1. SUBMITTAL TYPE: (Is this a resubmittal? Yes ☐ No ☒)			
Deferred Submittal ☐	Addendum Number: 01	Revision Number:	CCD Number: Category A ☐ or B ☐
2. PROJECT INFORMATION:			
School District/Owner: San Beranrdo City USD		DSA File Number: 36 H7	
Project Name/School: Indian Springs HS - Health Center		DSA Application Number 04 123900

ADDENDUM NO. 1

Indian Springs High School – Health Center

DSA #04-123900 FILE #36-H7 RCA Project No. 1-78-50

DEMO & NEW FLOOR PLANS

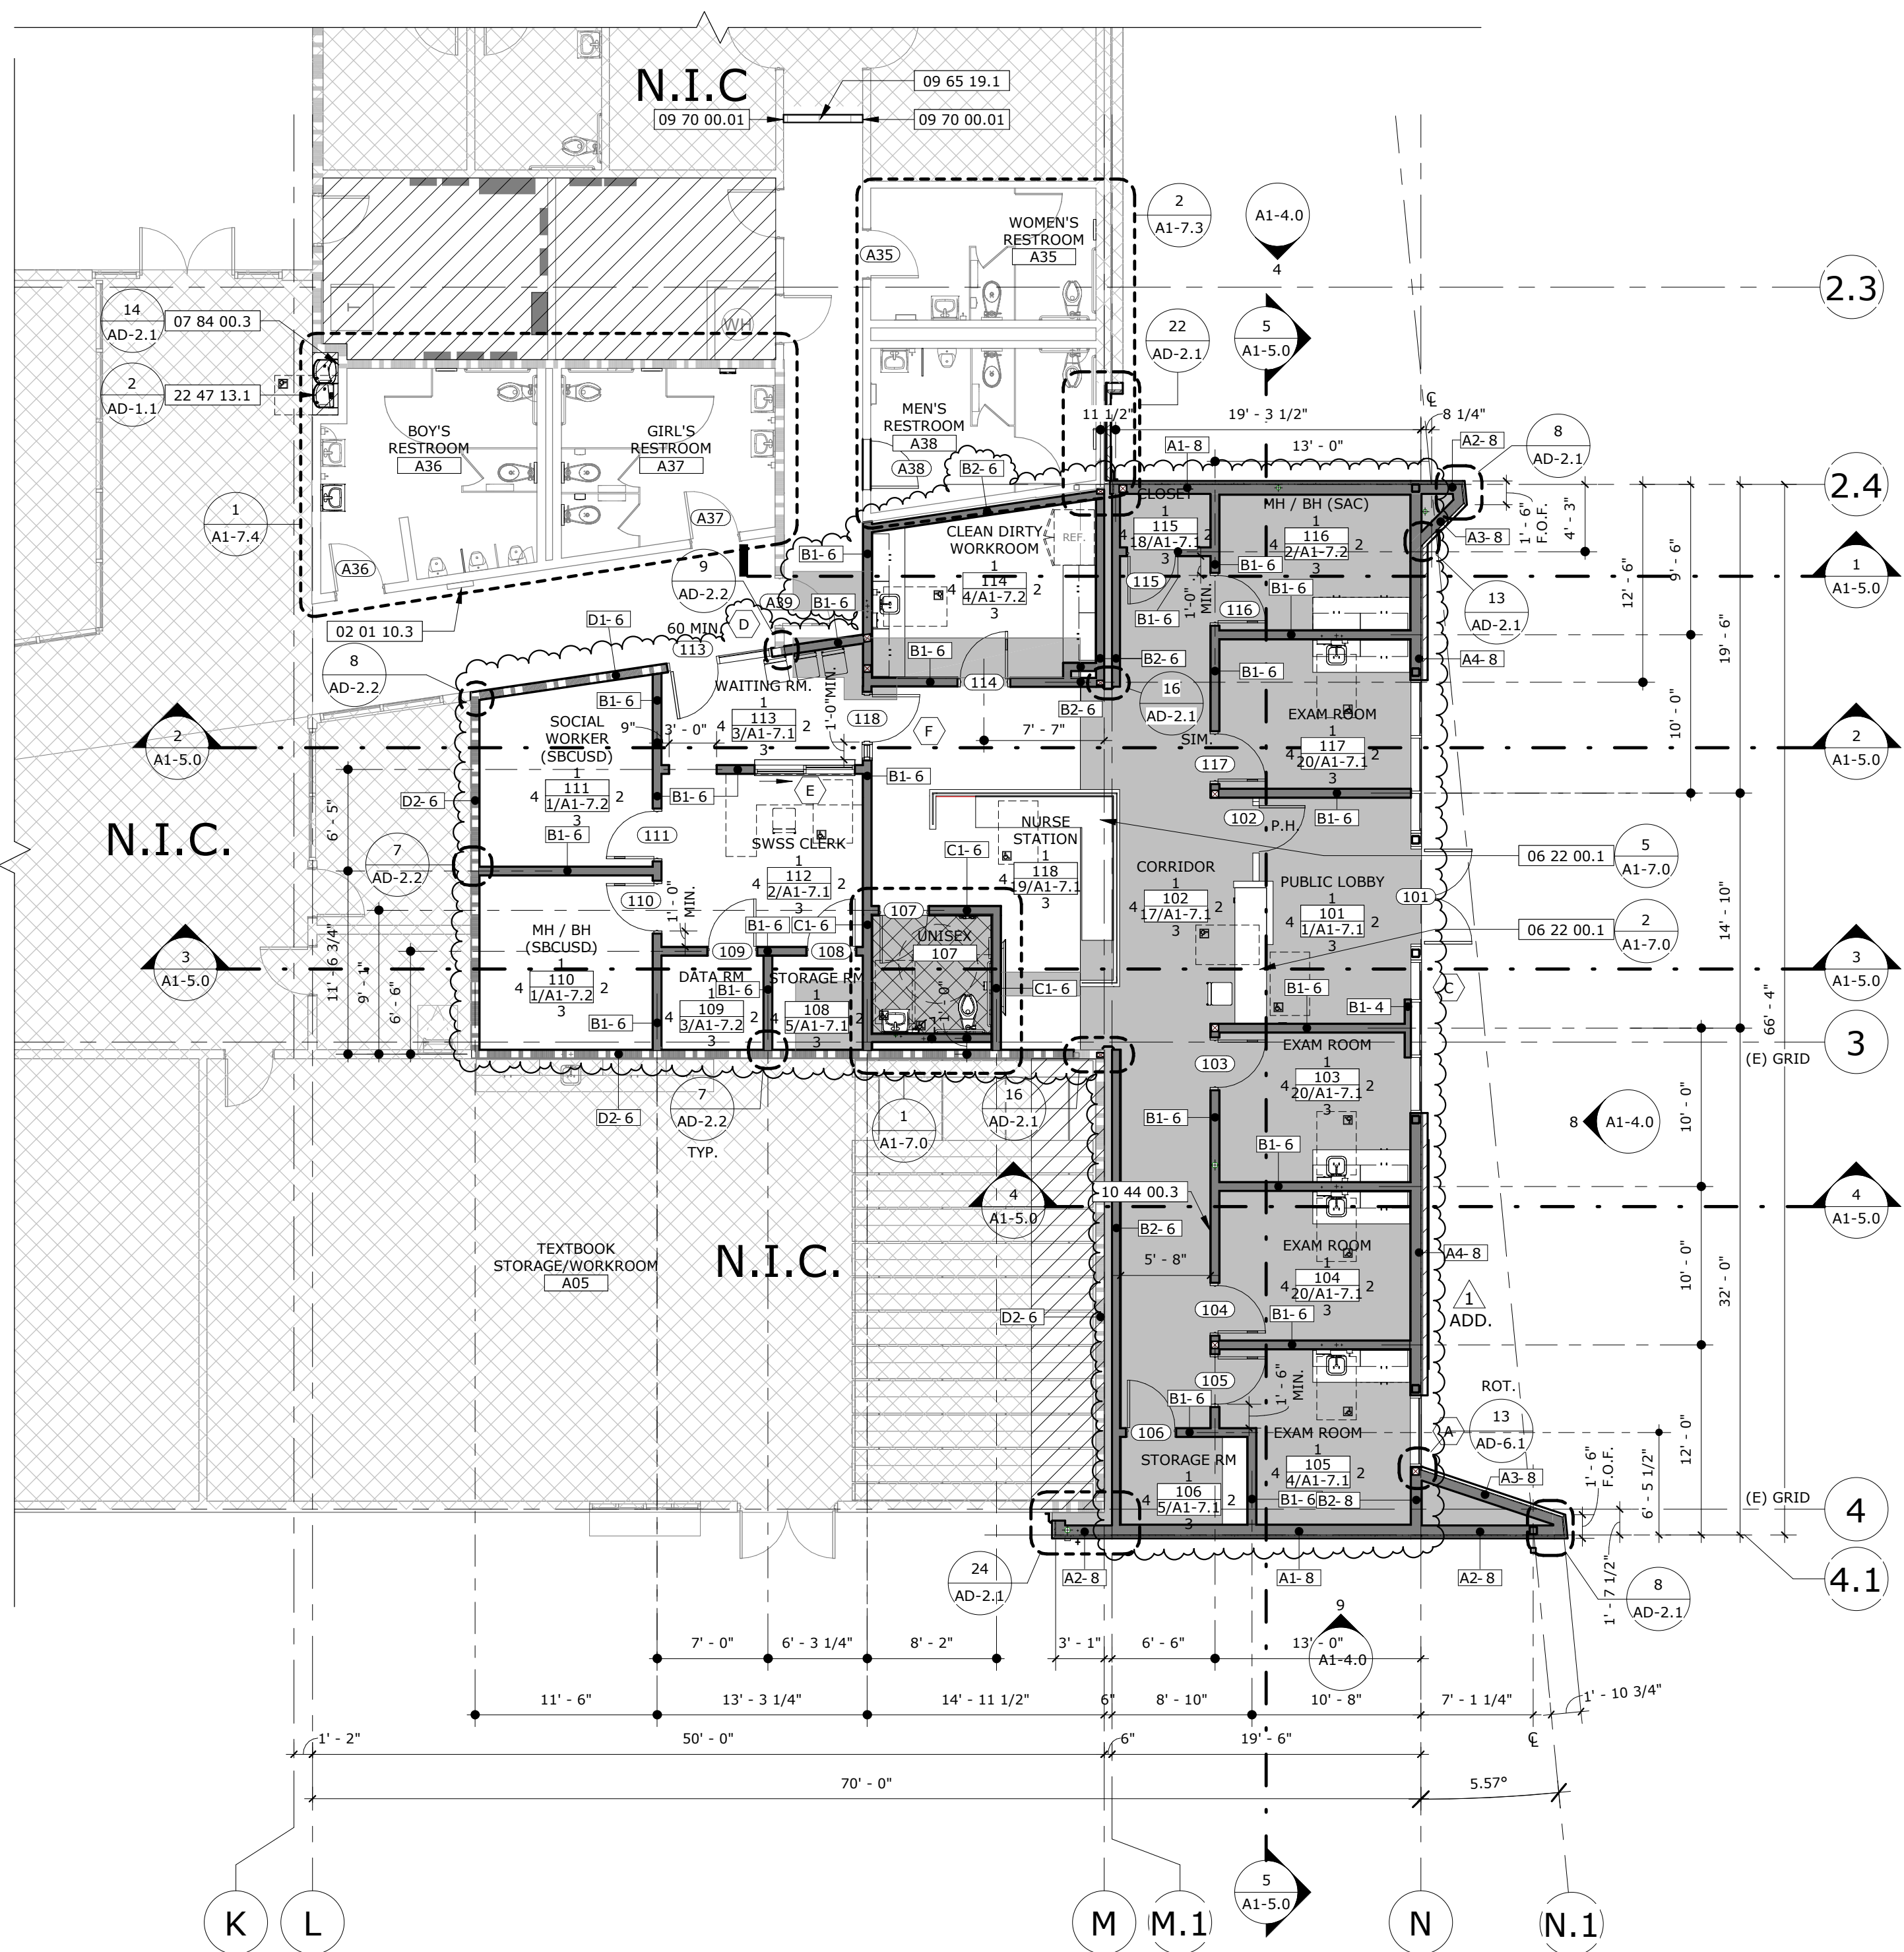
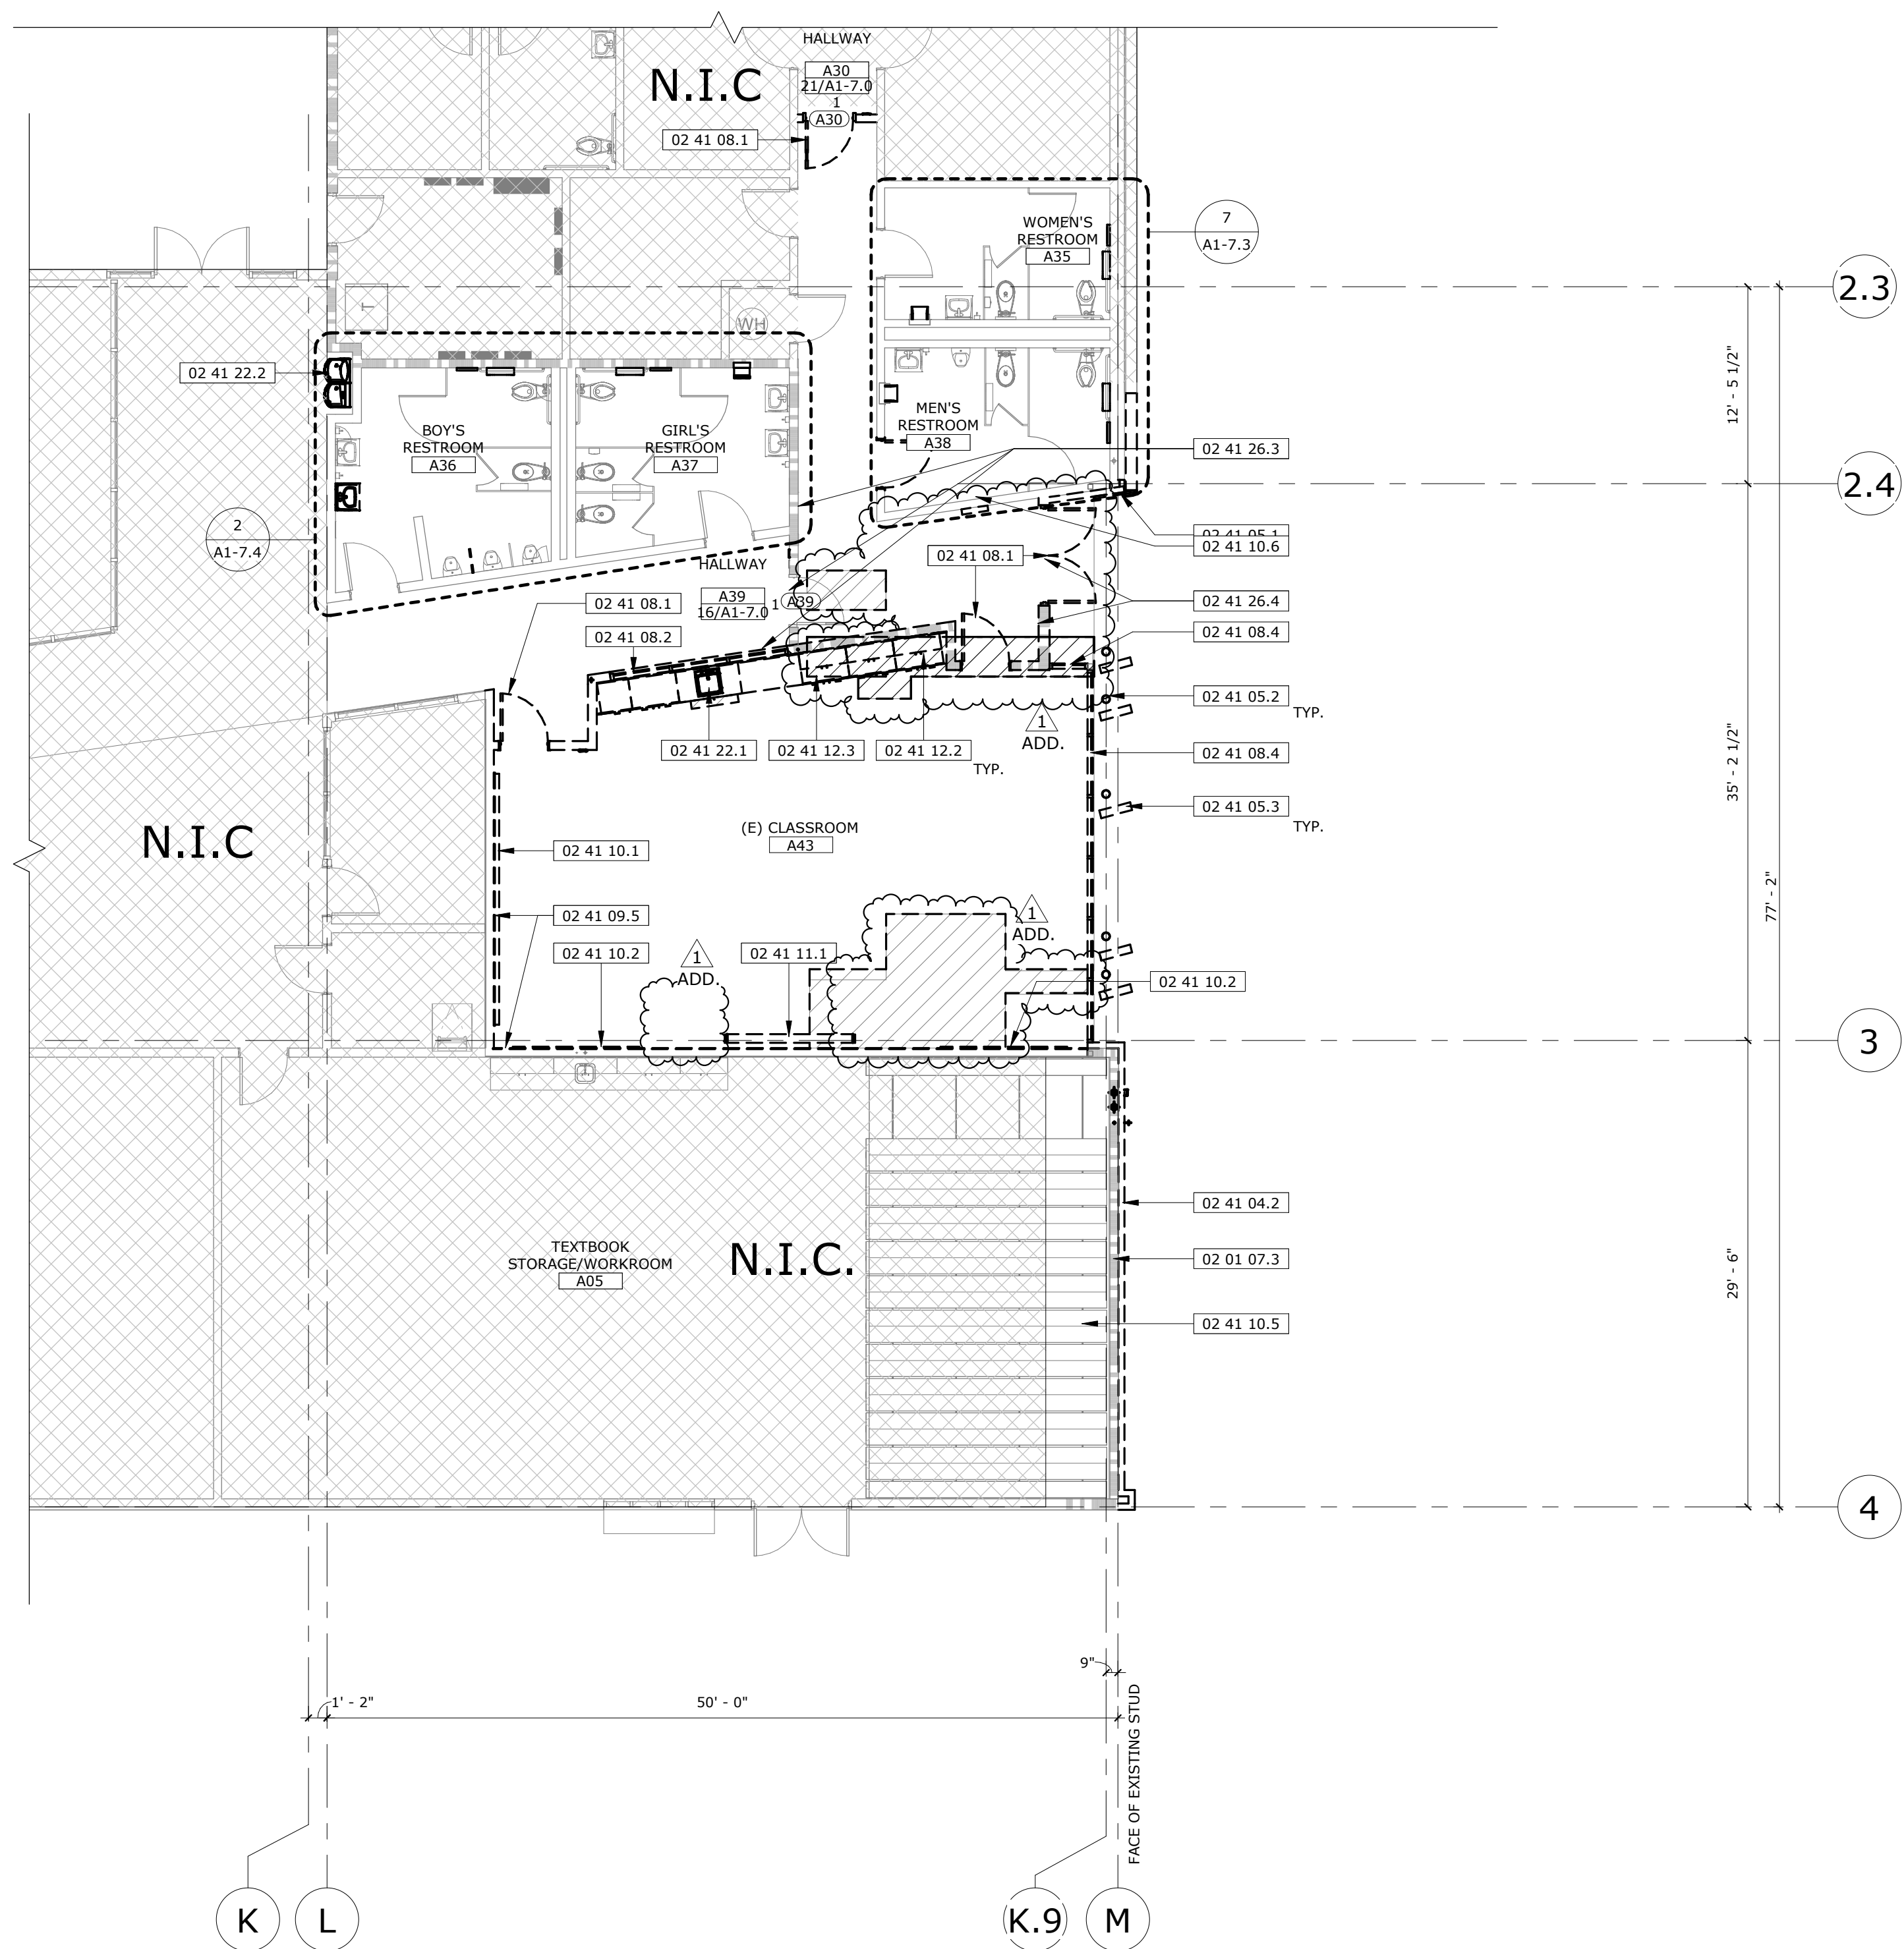
- Item No. 1.9 Reference Sheet A1-1.0 – DEMO & NEW FLOOR PLANS
1.9.1 Replace Sheet A1-1.0 and revise per clouded areas & items listed below:
 (a) Detail 1, Revised floor plan layout

(b) Detail 2, revised existing slab removals based on updated MEP layouts
- Item No. 1.10 Reference Sheet A1-2.0 – DEMO & NEW RCP
1.10.1 Replace Sheet A1-2.0 and revise per clouded areas & items listed below:
